UNITED STATES PATENT AND TRADEMARK OFFICE

APPLICATION NO.	FILING DATE	FIRST NAMED INVENTOR	ATTORNEY DOCKET NO.	CONFIRMATION NO.
09/653,527	08/31/2000	Vladimir Berezin	08305/078001/99-23	4646

Office Action Summary

DETAILED ACTION

11. The following figure includes the labels that will be used in the Kuroda rejection under 35 U.S.C. 102(e):

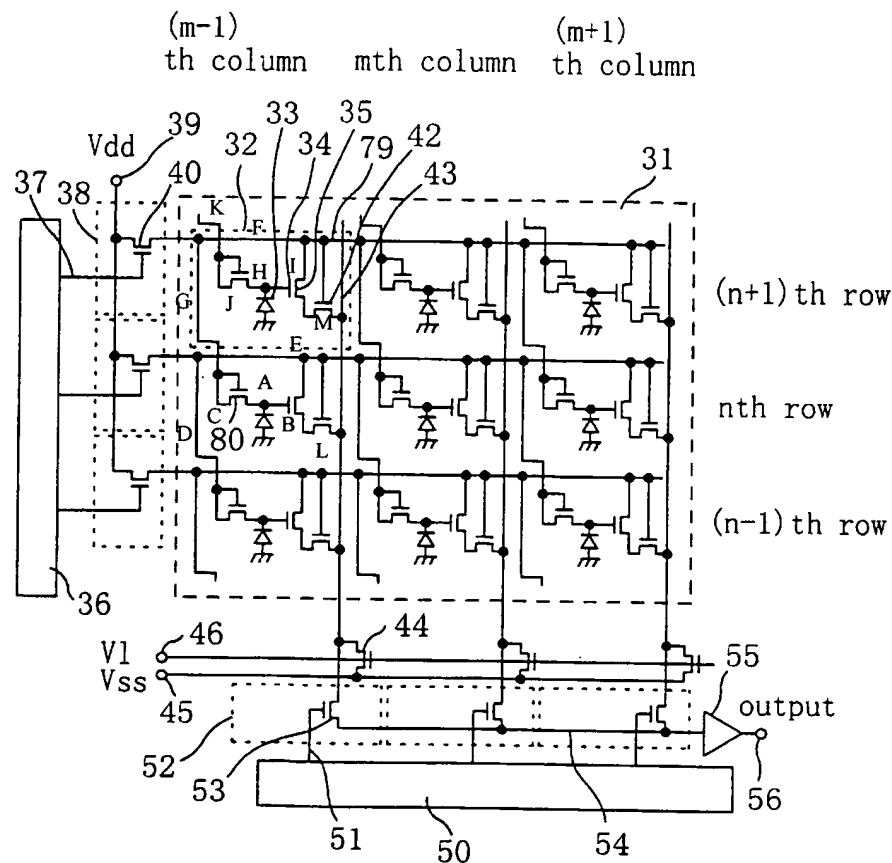
12. Claims 22-28 are rejected under 35 U.S.C. 102(e) as being anticipated by Kuroda (U.S. Patent No. 6,512,543).

Regarding **claim 22**, Kuroda discloses an image sensor, comprising:

a first pixel (D), said first pixel comprising a first photoreceptor (A), a first follower transistor (B; see column 6, lines 57-58) having a gate connected to said first photoreceptor, a drain of said first follower transistor connected to a first line (E), and a first reset transistor (C; see column 9, lines 19-20), a drain of said first reset transistor connected to a second line (F); and

a second pixel (G), said second pixel comprising a second photoreceptor (H), a second follower transistor (I) having a gate connected to said second photoreceptor, a drain of said second follower transistor connected to said second line (F), and a second reset transistor (J), a drain of said second reset transistor connected to a third line (K).

a third pixel (the above figure can have more pixels than those shown; see column 9, lines 15-24), said third pixel comprising a third photoreceptor (corresponding to H in an unshown pixel above pixel G), a third follower transistor (corresponding to I) having a gate connected to said third photoreceptor, a drain of said third follower transistor connected to said third line (K), and a third reset transistor (corresponding to J), a drain of said third reset transistor connected to another line (corresponding to K).

said first pixel further comprises a first select transistor (L) connected to said first follower transistor, said second pixel further comprises a second select transistor (M) connected to said second follower transistor.

said second select transistor and said first reset transistor each have a gate connected to a first reset/select line (F).

a gate of said first selected transistor is connected to a second reset/select line (E).

a gate of said second reset transistor is connected to a third reset/select line (K).
